ROOF REPLACEMENT CAPITAL PLAZA

FRANKFORT, KENTUCKY

REVISION NO. 1 11 APR. 2005

"AS-BUILT" NOTE:

PLAN A
A-4 3/32" = 1' - 0" SOUTH HALF OF CONSTRUCTION AREA NORTH

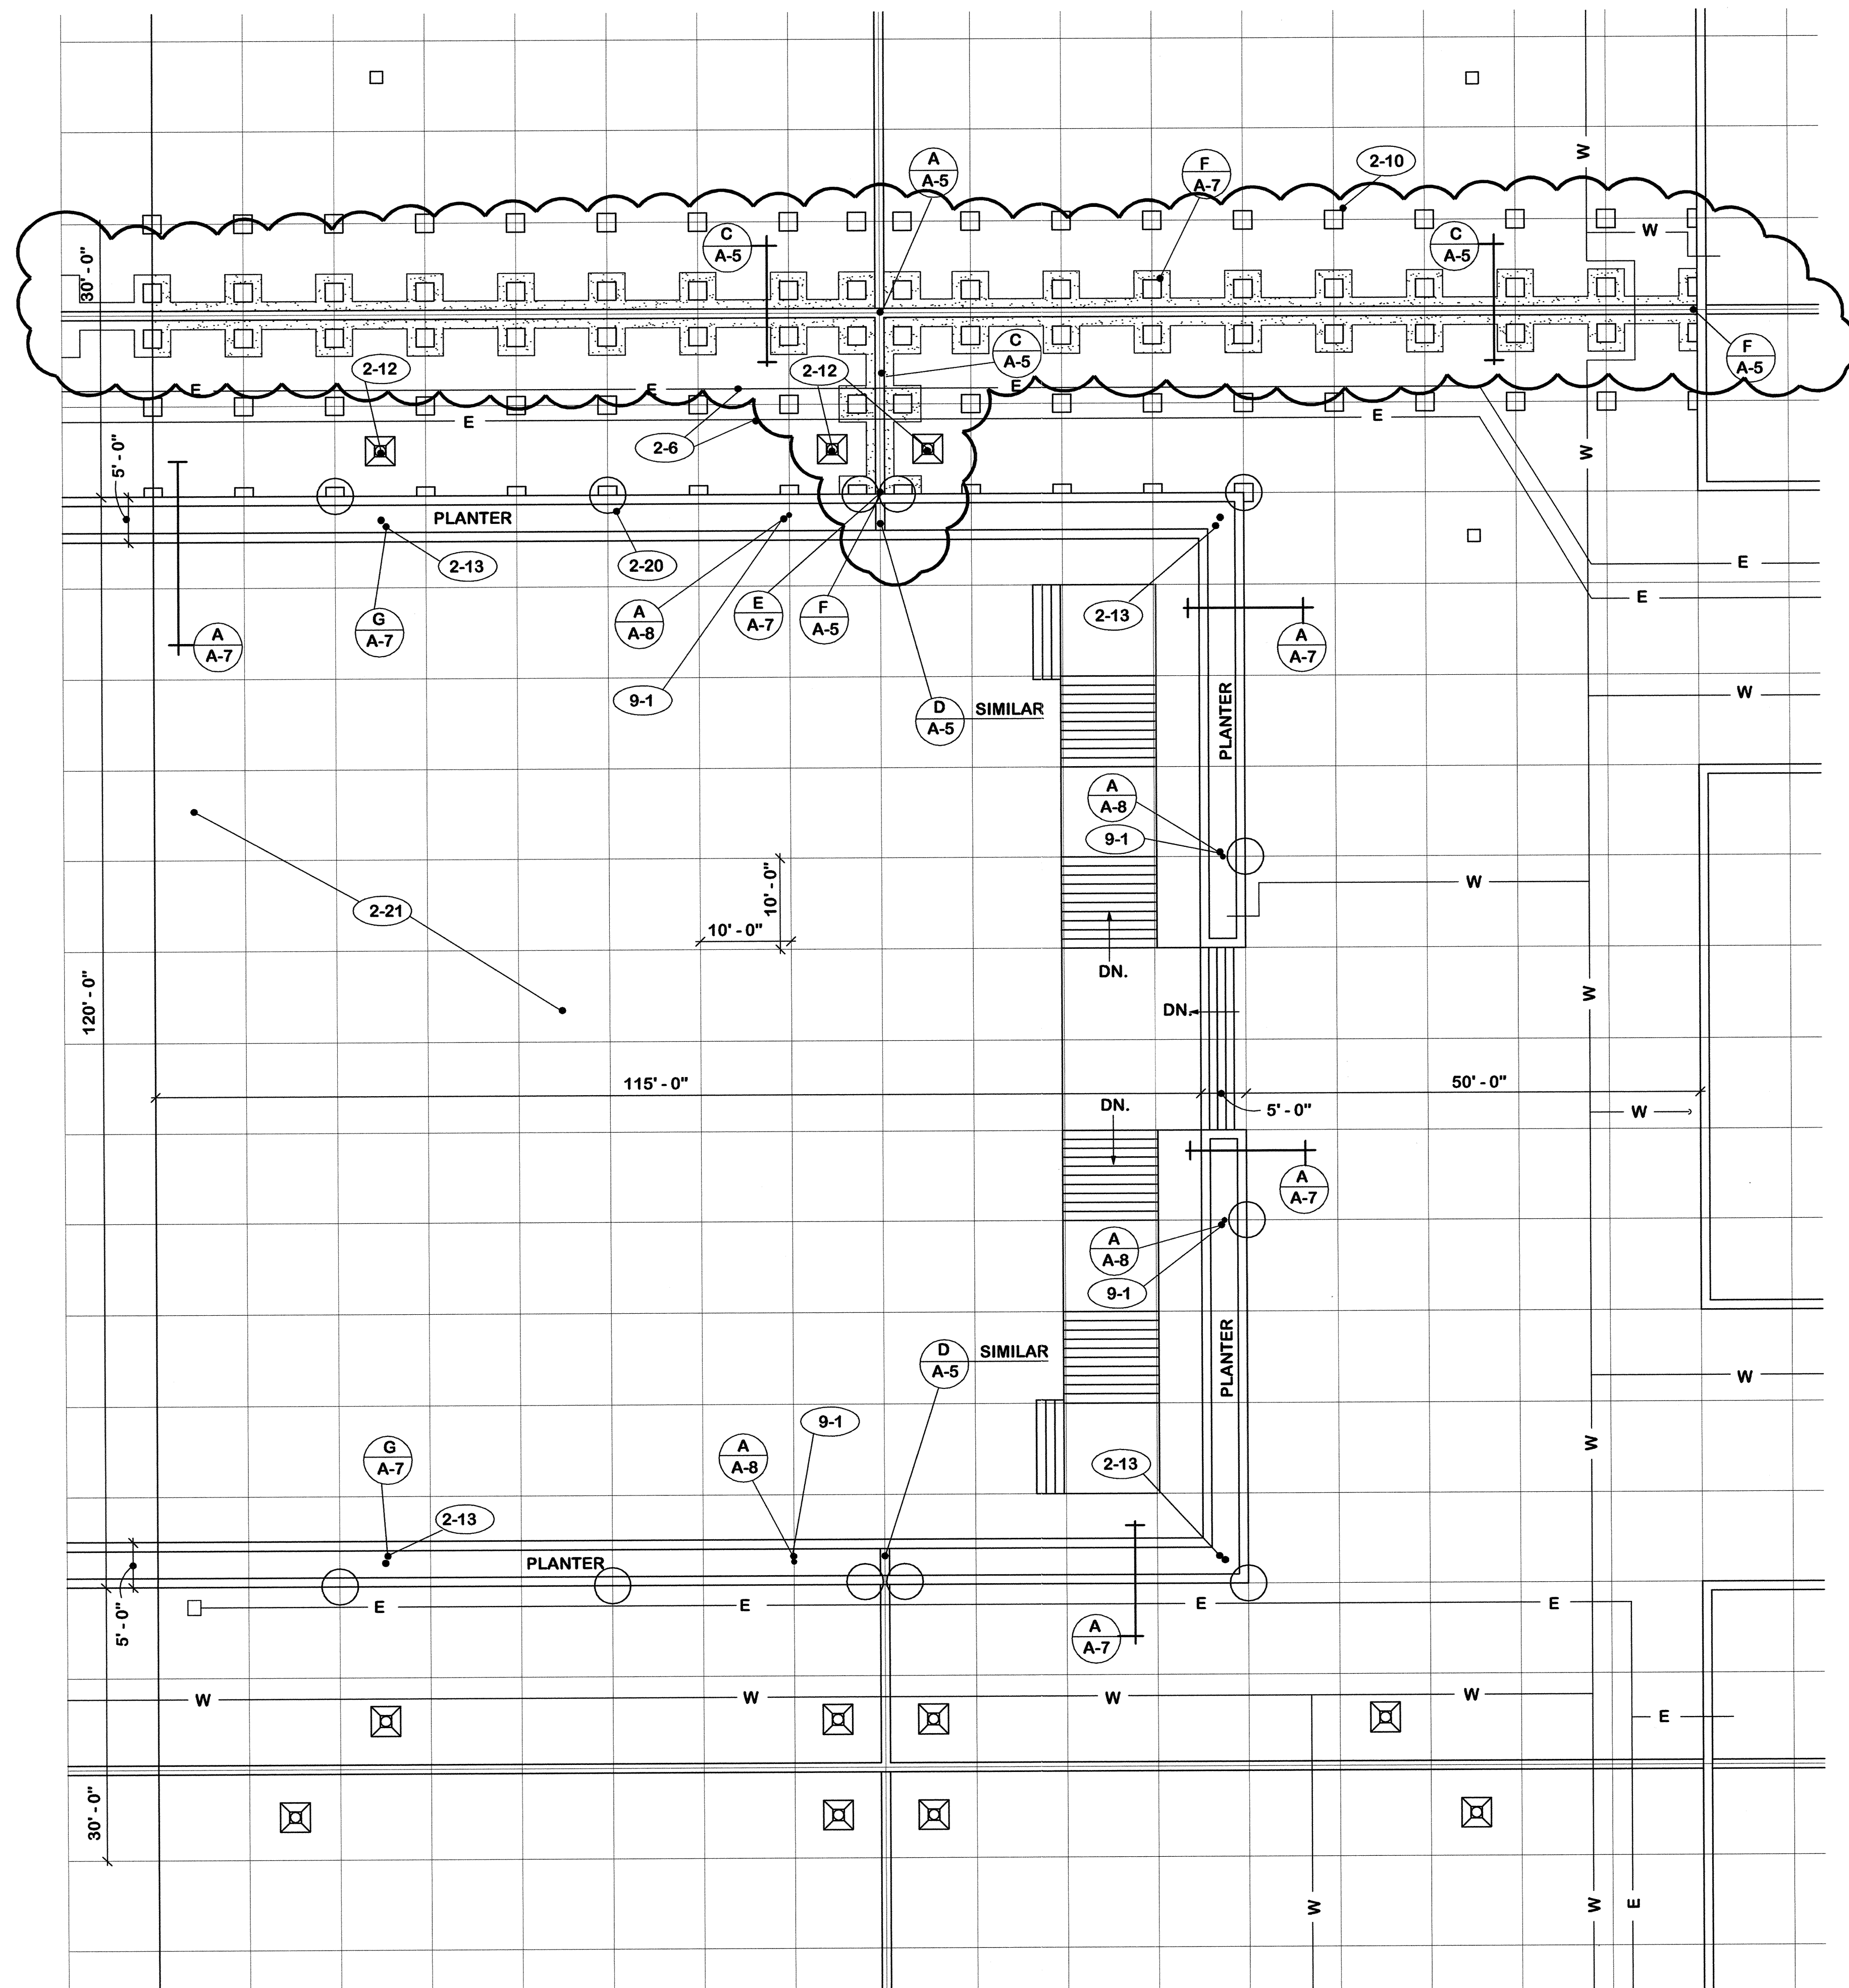
NOTE "A" (change no. 1)
 1. Revised work required at expansion joint. See sh. A-11.
